TITLE: ASSY, CONTROL CABINET BOX 245kV (GCB)

SIZE D | FSCM NO. | DWG. NO. 41-4311-XX | REV. 19

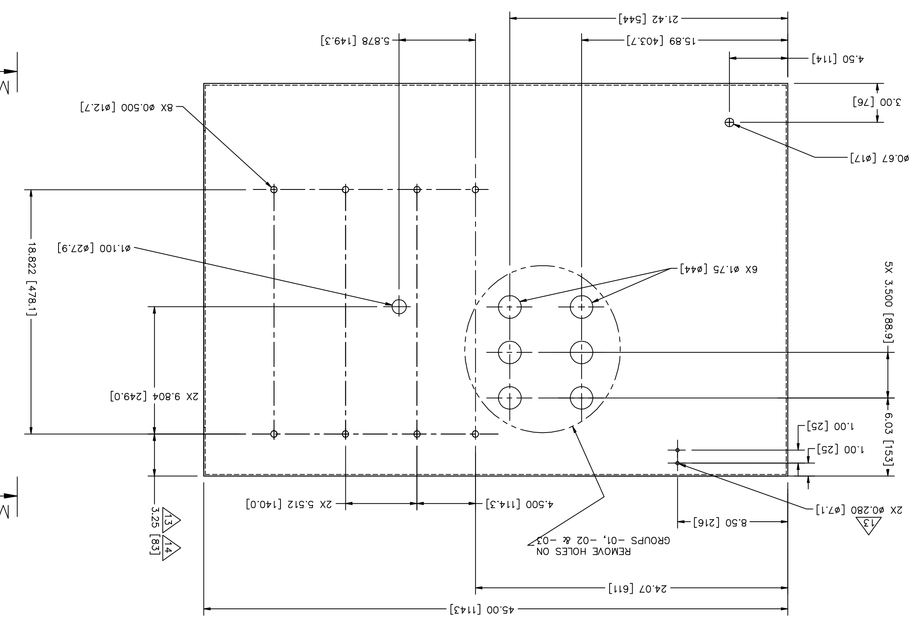
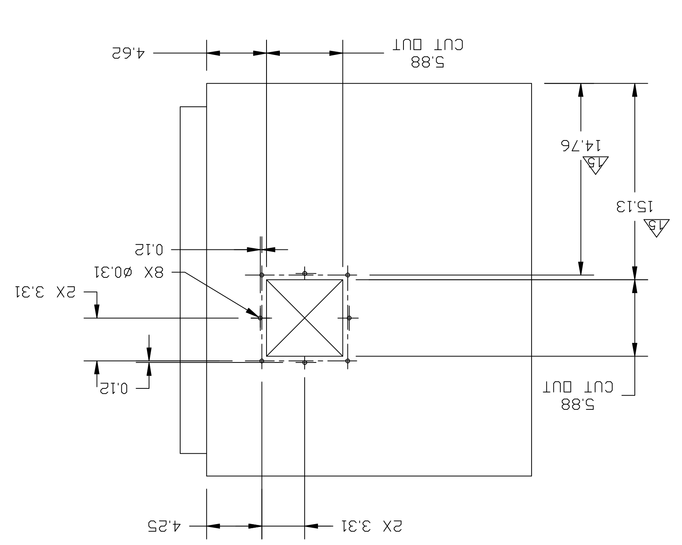
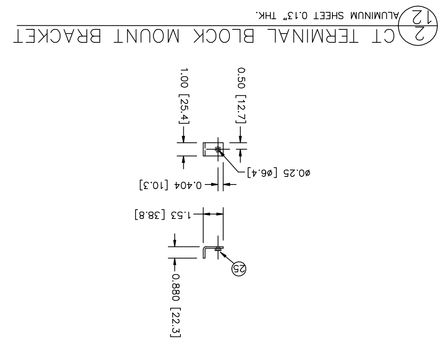
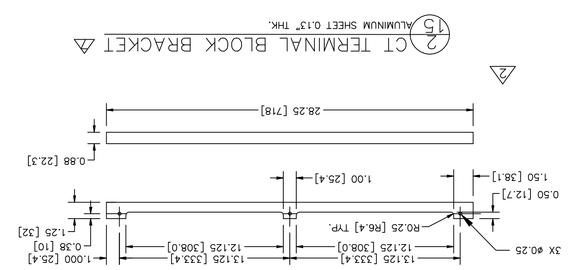
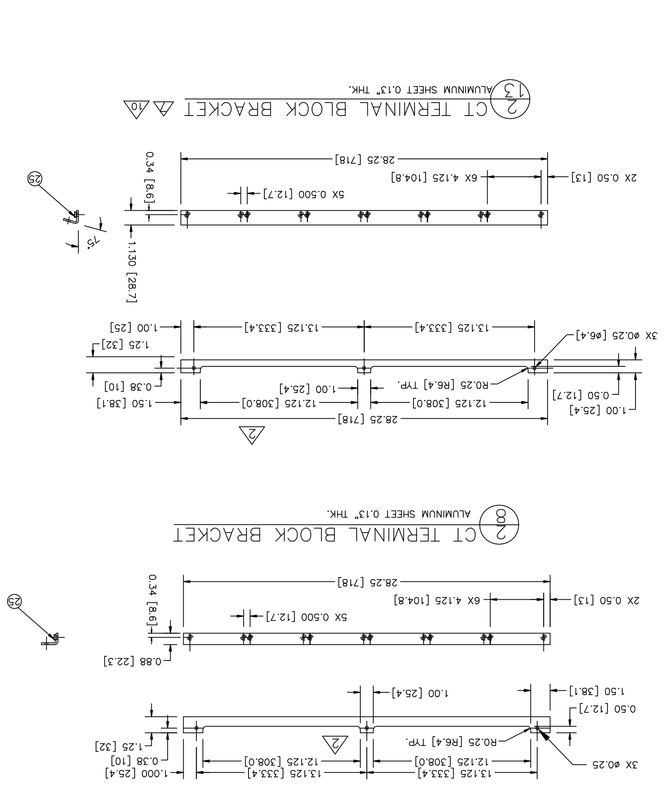
ZONE	REV	DESCRIPTION	DATE	APPROVED
	0	RELEASED PER ECO 060095	08/16/06	
	1	PER ECO 060123, ADDED 6" TO WIDTH, MOVED DOOR POCKET DOWN 3", ADDED 1.25" TO HEIGHT, OTHER CHANGES SEE REV. CLOUDS.	10/11/06	
	2	PER ECO 070003, ADDED MISSING DIMENSION 3.274 & GROUP –04 TO –03.	1/8/07	
FAGE1 PAGE2	3	ECO 070086: CHANGED TO NEW SWITCH BRACKET, 4 X ø0.181 WAS 2 X ø0.181 MOVED DOWN (3.25") THE INSTRUCTION BOOK BRACKET ④	11/12/07	C.R.
F7.66 PAGE2	4	ECO 070087; CHANGED DOOR ROD STOP	11/20/07	C.R.
F3 PAGE2	5	ECO 070090: ITEM 28 REPLACES ITEM 26	11/21/07	C.R.
PAGE3	6	ECO 080023: ADDED ITES 29, 30, SHEET 3	03/10/08	C.R.
PAGE1 PAGE2	7	ECO 080052: ADDED DIMENSION 5.51 DELETED ITEM 2, DELETED PRESS NUT FROM ④ ⑤ ADDED PRESS NUTS TO ④	07/14/08	C.R.
PAGE2 G8	8	ECO 080058: MOVED THE DOOR HANDLE MOUNTING HOLES 0.25" FAR FROM DOOR EDGE	7/25/08	C.R.
	9	ECO 080061: CHANGED THE DOOR HANDLE/LATCH TO 3 POINTS LATCH, REMOVED THE PERMATON FILTER MODIFIED ④	8/01/08	C.R.

PAGE2 PAGE3	10	ECO 090018: REARRANGED THE BRACKETS DETAILS, ADDED PEMNUT TO ④, REPLACED ONE BRACKET ④ WITH ④	3/19/09	C.R.
PAGE2 G4		REDUCED THE # OF HOLES ø0.188, AND RELOCATED THEM		
B2 PAGE3	11	ECO 090060: ADDED GROUP –04 (VIEW C–C)	7/9/09	C.R.
G2 PAGE2	12	ECO 090073: MOVED HEATER BRACKETS (VIEW N–N)	9/3/09	C.R.
PAGE3	13	ECO 090083: 4.06 WAS 3.55 (VIEW N–N)	9/21/09	C.R.
PAGE3 PAGE2 PAGE1		ADD VIEW M–M, 2 X ø0.280, FOR –04 ONLY VIEW I–I (–00, –01, –02, –03) ADD –04 FOR VIEW B–B, –03, –04 FOR GASKET AND CONDUIT PLATE ADD SS AT EACH STAINLESS HARDWARE DESCRIPTION		
C2 SHEET3	15	ECO 100082: 15.13 WAS 14.75, 14.76 WAS 14.38 (VIEW M–M, GROUP –04)	11/16/10	C.R.
D3 PAGE3	14	ECO 100028: 3.25 WAS 4.08 (VIEW C–C, GROUP –04)	5/21/10	C.R.
D1 SHEET2	17	ECO 130003: ADDED ø.181 HOLE ONTO ITEM ⑭ AND UPDATED ITEM ⑭ PANEL ON SHEET 2.	1/09/13	W.W.
H5 SHEET2	16	ECO 120160: ITEM 31 REPLACES ITEM 22	11/27/12	C.R.
F5 REV. 1	18	ECO 130048: ø0.790 WAS ø0.67	4/29/13	C.R.

19	ECO 130072: RE–DESIGNED DOOR LATCH & GASKET, REVISED BOM ACCORDINGLY	8/19/13	C.R.
